United States Department of the Interior

Re: Minor Modification to the Approved Resource Recovery and Protection Plan - Relocate South Mains Development in the Skyline Mine No. 3

SKYLINE MINE 3 SOUTH MAINS MINOR MODIFICATION

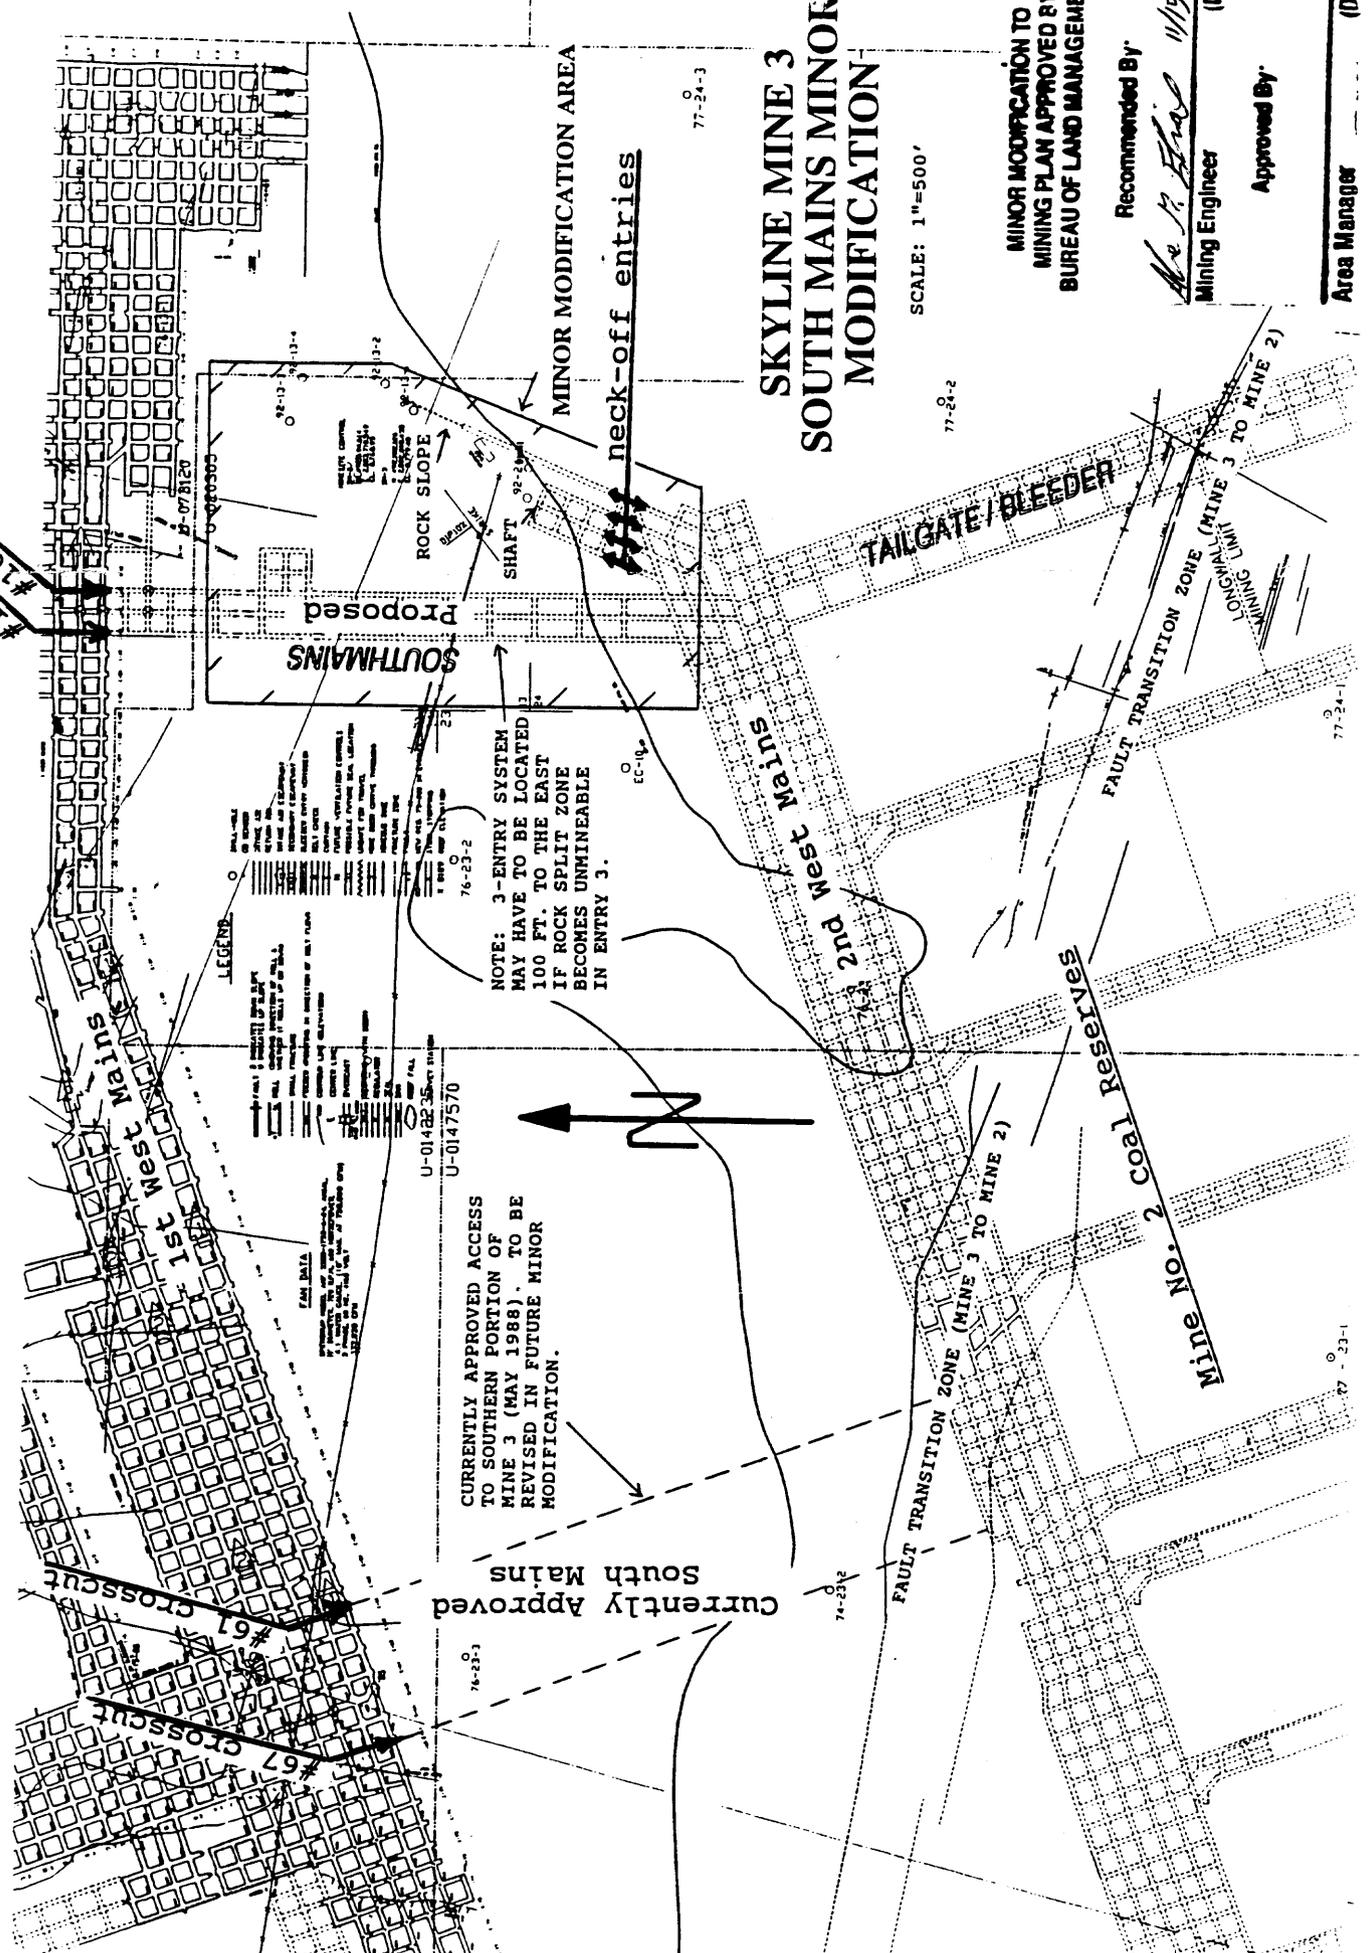
The currently approved mining plan was to develop the South Mains in mine No. 3 between #61 and #67 crosscuts of the 1st West Mains (see enclosure). UFC is now proposing to develop the South Mains between #16 and #18 crosscuts; development may be shifted 100 feet to the east. UFC also proposes to neck four entries off the 2nd West Mains.

The currently approved plan (May 1988) shows that the South Mains development is in the Lower O'Connor-A coalbed. The approved location is overlain by two undeveloped coalbeds (the Upper O'Connor and the Lower O'Connor-B). Also, the development will intersect a fault zone with 35 feet vertical displacement. The fault zone was witnessed and documented by a BLM mining engineer from the Price Coal Office. On August 1, 1989, the 2nd West Mains of mine No. 1 in the Upper O'Connor coalbed progressed through the fault and a highly fractured zone. On May 23, 1990, the same fault prevented the advancement of the 1st West Mains of mine No. 3 beyond #103 crosscut.

No reserves in the Lower O'Connor-A coalbed are above the proposed area. Proposed mining is partially under the portal entries of mine No. 1. Development will be under 400 feet of overburden and under 145 feet of interburden that contain 87 percent sandstone. Available geologic information shows that the South Mains may be developing through a zone of rock splits. Shifting the proposed development 100 feet to the east will not superimpose protective barrier pillars for the South Mains in the Skyline Mines No. 1 and No. 3.

Based on the BLM's observations, analysis, and standard industry operating practice, relocating the South Mains development will reduce the risk of losing coal reserves due to multiple coalbed mining. The proposed development will provide shorter and cleaner access to mine No. 2 and will also enhance ventilation. The proposed neck-off entries will be used to develop a shaft and a slope that will provide ventilation and coal haulage for mine No. 2 in the future. Shifting the proposed development 100 feet to the east may endanger entries stability for the South Mains in both mines No. 1 and No. 3.

Therefore, the BLM authorizes UFC to develop the South Mains between #16 and #18 crosscuts of the 1st West Mains and neck-off four entries for the future construction of shaft and rock slope in the Skyline Mine No. 2. Development should remain in the proposed location or shifted to the east more than 100 feet, leaving an adequate barrier pillar to protect the South Mains in both mines No. 1 and No. 3. Exact location should be submitted to the BLM for filing no later than 30 days after your receipt of this letter.
